**Addendum #1 for the City of Corcoran
Water System Meter Installation Project**

August 26, 2022

Addendum #1:

A7: Appendix A: 3/4" and 1" Residential Water Service.

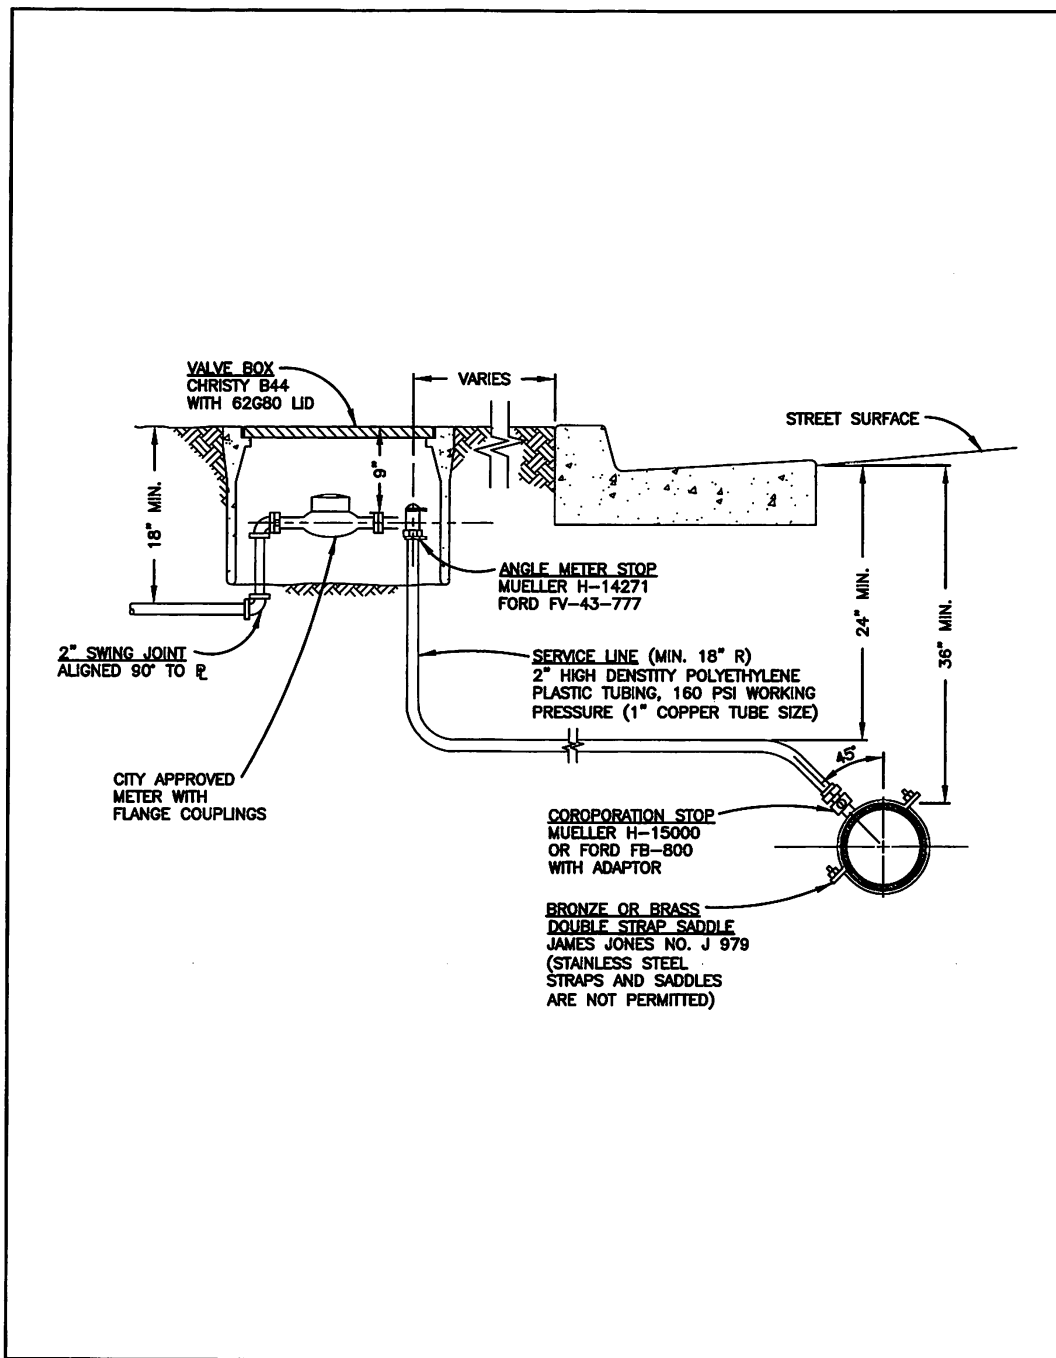
Q7: Details for Appendix A and B are not showing up on the bid documents. Please provide an image of Appendix A and B.
